ADDENDUM NO. 1
OCTOBER 29, 2018
ERIE INTERNATIONAL AIRPORT
SECURITY FENCE UPGRADE

ADDENDUM NO. 1
OCTOBER 29, 2018
ERIE INTERNATIONAL AIRPORT
SECURITY FENCE UPGRADE

ERIE INTERNATIONAL AIRPORT, TOM RIDGE FIELD SECURITY FENCE UPGRADE PROJECT

2 ————— **FENCE TOP DETAIL** —————
NOT TO SCALE

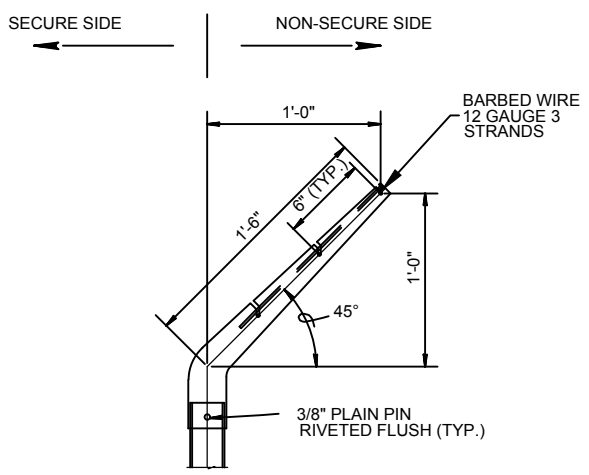
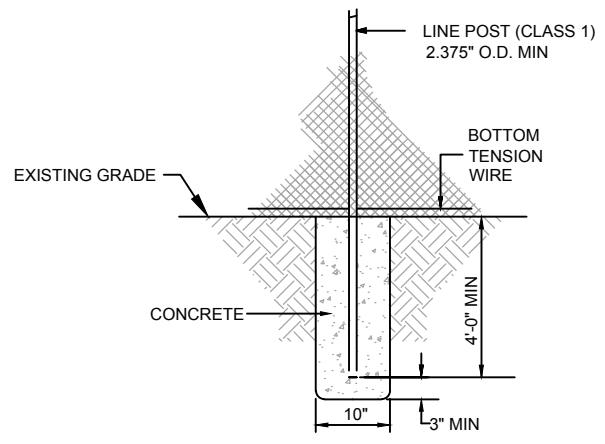
1. Tension wire. Are we supposed to install tension wire only where we are replacing fence, or do we need new tension wire even in the places where we just installing barbed wire?

Response: Top and bottom tension wire shall be installed on new fence section. Top tension wire shall be installed on existing fence where barbed wire is being placed.

4 TYPICAL CORNER/END/TERMINAL POST
NOT TO SCALE

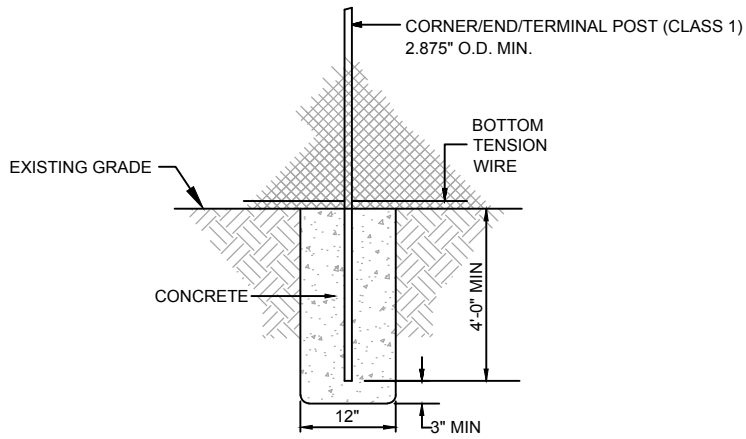
3. Do we need to replace concrete in places where we are replacing fence posts?

Response: Yes, new fence posts shall be installed in new concrete post foundation.

5 FENCE GROUNDING
NOT TO SCALE

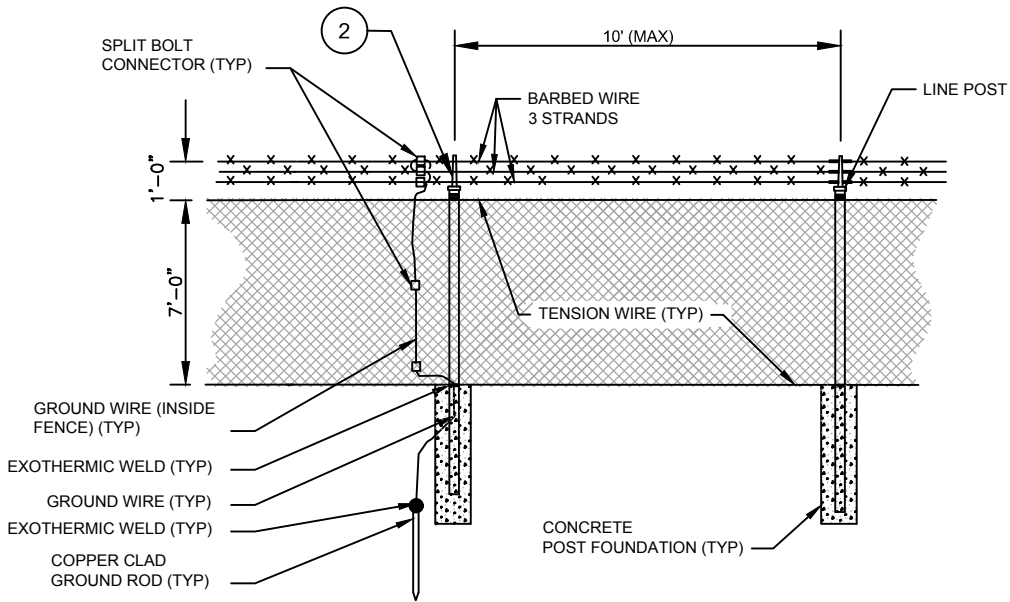
2. Copper clad ground rod. Do we need to install it only where we are installing new fence or also where we replace existing posts? Also, will you require electrician to do it?

Response: Ground rods only need to be installed at new fence as indicated on the fence details (2 each, 1 at either end). The installation of the ground rods needs to be performed by an Electrical Contractor/Electrician that is qualified to install ground rods and meet the requirements as set forth in the specifications.
